service bulletin

No. 86-24

Official Notification Under the U.S. Federal Boat Safety Act

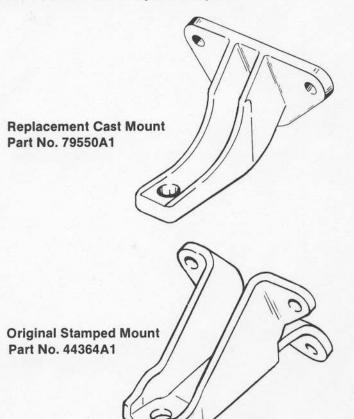
MerCruiser 454 Magnum engines in the following serial number group, A631894 thru B522239, (manufactured between January 1986 and August 1986) have front motor mount brackets that may crack and/or break under certain operating conditions. These conditions, such as jumping wakes or high speed operation in rough water may apply excessive forces to the mount brackets. When operating under these conditions the engine breaks loose from its mounting, and severe boat damage may result. We are initiating this defect notification to have the motor mount brackets replaced. The attached letter is being sent by certified mail to all known owners of these engines.

Suspect engines listed must have the motor mount brackets replaced. Remove stamped motor mount brackets 44364A1 and replace with cast motor mount bracket part number 79550A1. Each engine requires two motor mount brackets. Remove and install motor mount brackets per instructions following.

- 1. Remove out drive.
- 2. Support front of engine with a suitable hoist.
- 3. Remove top adjustment nuts from both engine mounts.
- 4. Loosen rear engine mounts a few turns.
- 5. Raise engine using hoist.
- Remove engine mount between brackets from engine block. Retain lock washers, discard bolts.

- Install new engine mount brackets using bolts supplied and lock washers retained from oil bracket. Torque bolts to 30 lbs. ft. (41 N.m)
- 2. Lower engine onto motor mounts and install top adjustment nuts.
- 3. Tighten rear motor mount bolts securely.
- 4. Check engine alignment as outlined in appropriate service manaul.
- 5. Tighten mount adjustment nuts and bend locking tabs.
- 6. Install drive unit.
